MAJOR PROJECT ASSESSMENT:
West Wallsend Colliery
Continued Operations Project

Director-General's
Environmental Assessment Report
Section 75I of the
Environmental Planning and Assessment Act 1979

January 2012

Figure 14: Noise Receiver Locations

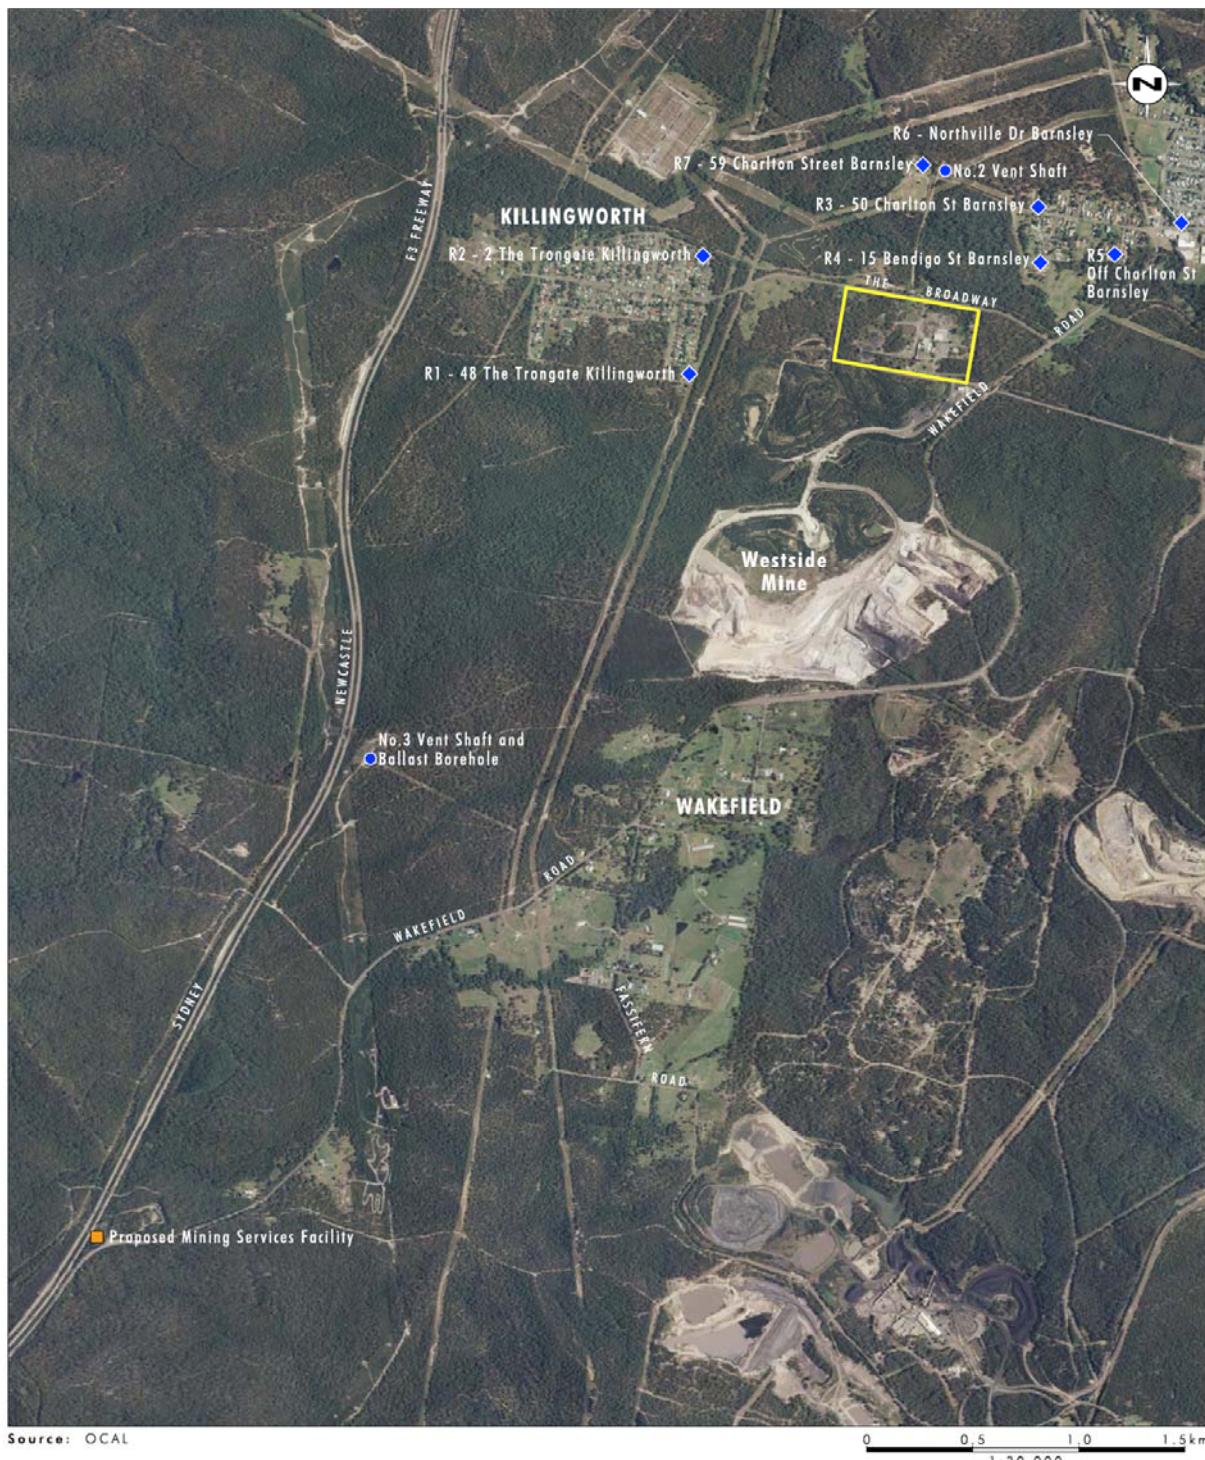
The EA provided noise measurements and data used to derive proposed rating background levels (RBLs) and project specific noise levels (PSNLs) for the project (**Table 6**). However, the Department was not satisfied that this data was sufficient to reliably calculate noise criteria. As a result, OCAL provided more detailed noise data to the Department, which then calculated PSLNs to reflect the more stringent of the noise levels derived from both intrusive and amenity criteria, in accordance with the INP. The PSLNs provide initial target noise levels used to derive achievable noise limits based on the implementation of feasible and reasonable control measures. Both the Department and OEH have reviewed the PSLNs adopted in the EA and are satisfied that they are appropriate.

The existing and predicted worst-case noise levels at all key receiver locations are shown in **Table 6**. To interpret the locations referred to in **Table 6**, see **Figure 14** and the lists in **Appendix G**. The noise modelling results indicate that, under worst-case meteorological conditions, noise generated from the Pit Top Facilities and the No. 2 Vent Fan would result in exceedances of the PSLNs in both Killingworth and Barnsley. However, the operation of the Mining Services Facility would not cause adverse noise impacts on the residences in the vicinity of Wakefield.

The noise generated from activities at the Pit Top Facilities exceeds the PSLNs at 122 residences located in the northern part of Killingworth (ie R2) and 52 residences in the west and southwestern parts of Barnsley (ie R3 and R4). The magnitude of the exceedances at the closest residential receiver is up to 5 dB(A) above PSLNs during night-time periods. The assessment indicates that the coal breaker is the highest contributor to these noise levels.

The noise generated from the No. 2 Vent Fan also results in noise levels of up to 7dB(A) above the PSLNs at the residential receiver located adjacent to the fan (ie R7). This prediction was made assuming that the fan would remain operating at 30% of its design capacity. The modelling indicates that operating the vent fan at full capacity would result in noise levels at this nearby receiver, the residences in Killingworth and the residences at Barnsley by 13 dB(A), 1 dB(A) and 4-5 dB(A) above the PSLNs, respectively. The Department notes that these noise levels are currently being experienced, and that no noise complaints have been received by OCAL over the last two years. However, the Department and OEH believe that OCAL should reduce future noise levels in order to meet contemporary noise criteria and ensure the future amenity of residents in neighbouring areas.

Finally, the Department has also recommended a condition requiring OCAL to prepare and implement a detailed Noise Management Plan for the project, which is to include ongoing investigations into further reducing noise levels generated by the Pit Top Facilities and by the No. 2 Vent Fan.

Figure 15: Aboriginal Heritage Sites

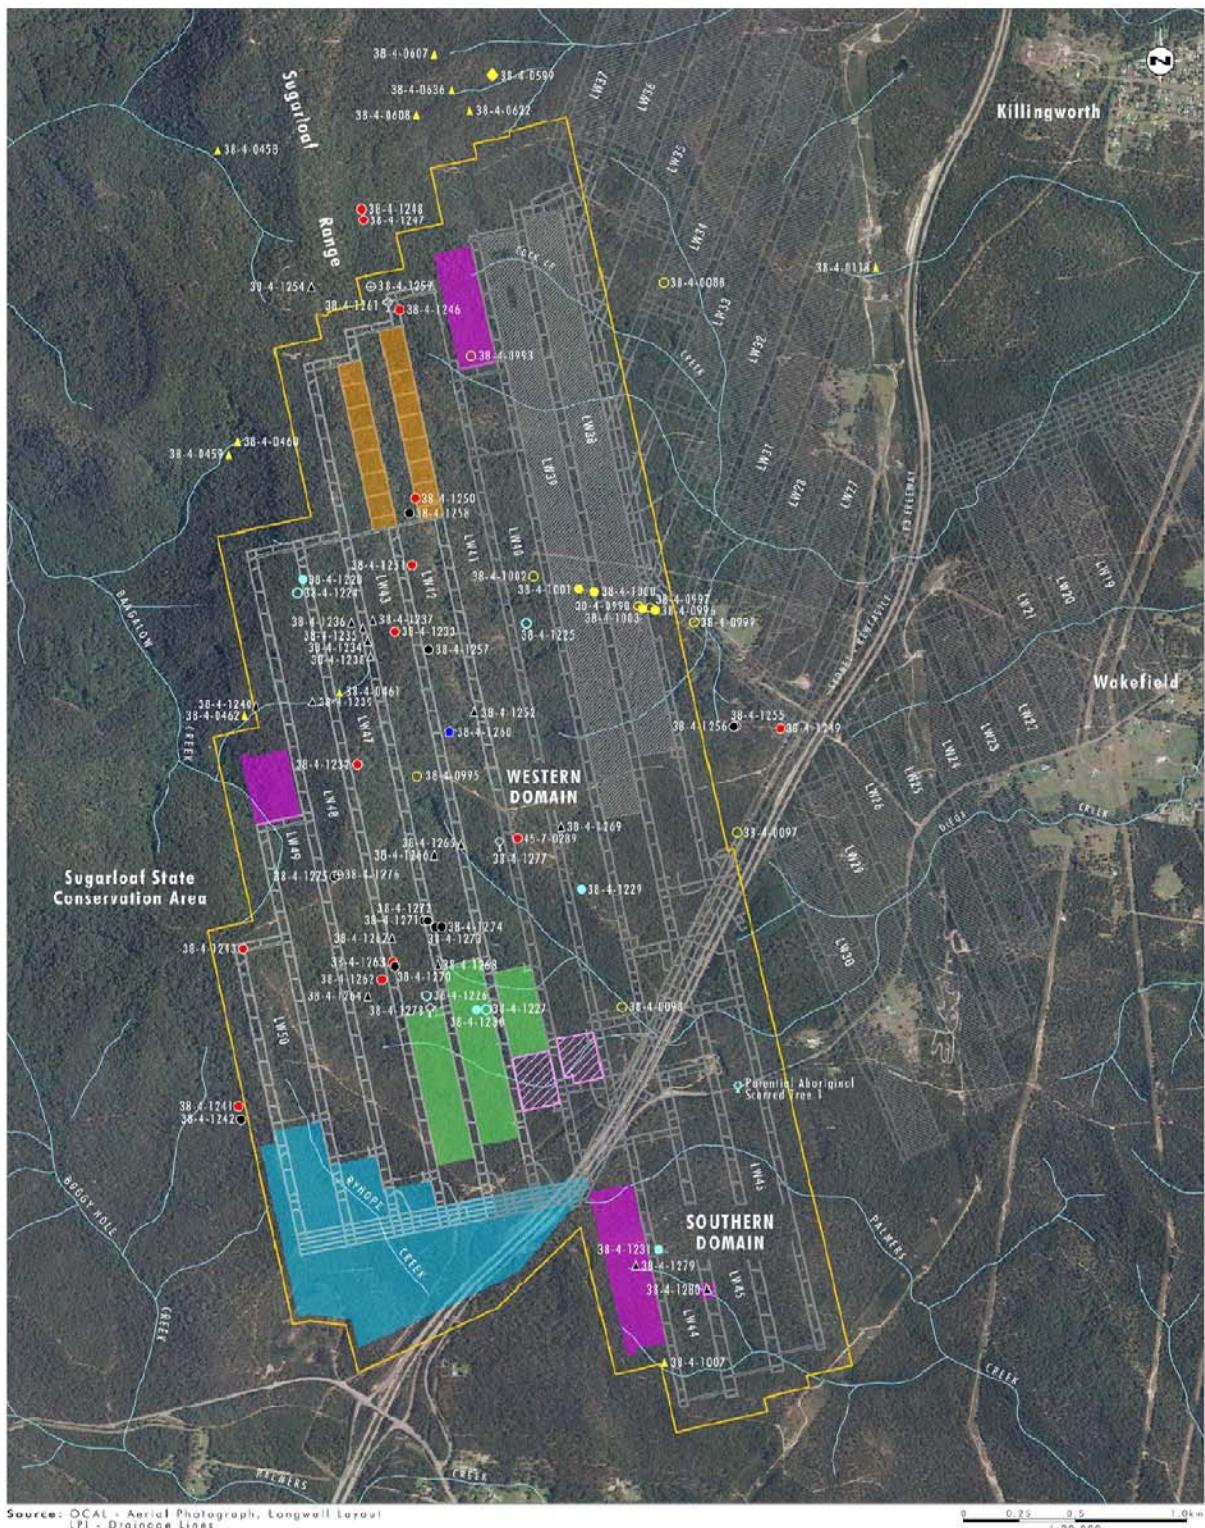
Consequently, OCAL has committed to modifying the mine plan to avoid impact to these sites and landscape features (see **Figure 15**). These mine plan changes have resulted in the sterilisation of approximately 2.04 Mt of coal resource, which is valued at around \$150 million. In addition, a further 3 sites of high to very high Aboriginal significance are proposed to be avoided as a result of mine plan modifications designed to reduce impacts on EECs and environmental flows in the vicinity of Diega Creek. These sites include a scarred tree (#38-4-1278), an artefact scatter (#38-4-1227) and an isolated find (38-4-1230).

In its assessment, Umwelt noted that further modifying the mine plan to avoid this cluster would have a major impact on the viability of the proposed continued underground mining operations at West Wallsend. However, it also states that, unless it can be demonstrated that there are similar sites with similar values within the Sugarloaf Range area that can be conserved for the benefit of future generations, it would not be possible for the project to achieve the ESD Principle of Intergenerational Equity if damage/destruction of these sites occurs.

Consequently, OCAL has proposed a conservation offset strategy to provide funding for further survey within the Sugarloaf SCA to confirm whether sites of a similar nature and similar significance exist and whether they can be managed for their long-term conservation, as an offset for any damage that may occur to these sites as the result of subsidence. It is proposed that the survey would include at least 20 days of fieldwork in consultation with Aboriginal stakeholders and would involve the compilation of site cards by a suitably qualified person. A statement in relation to the suitability of the sites located outside mining leases and within the Sugarloaf SCA as an offset is proposed to be prepared for consideration by OEH and the Department. If achievement of Intergenerational Equity can be demonstrated, and if the Bangalow Creek Grinding Groove sites are to be undermined, then mitigation would be undertaken in compliance with the Heritage Management Plan to be prepared as part of the Extraction Plan.

The Department has recommended a subsidence impact performance measure that requires OCAL to ensure that the project has negligible impact on these sites unless OCAL can demonstrate, to the satisfaction of the Director-General, that similar sites can be conserved within the Sugarloaf SCA and outside of a mining lease area. If this is not the case, OCAL would be required to modify the mine plan to avoid the sites. OEH is satisfied with this approach.
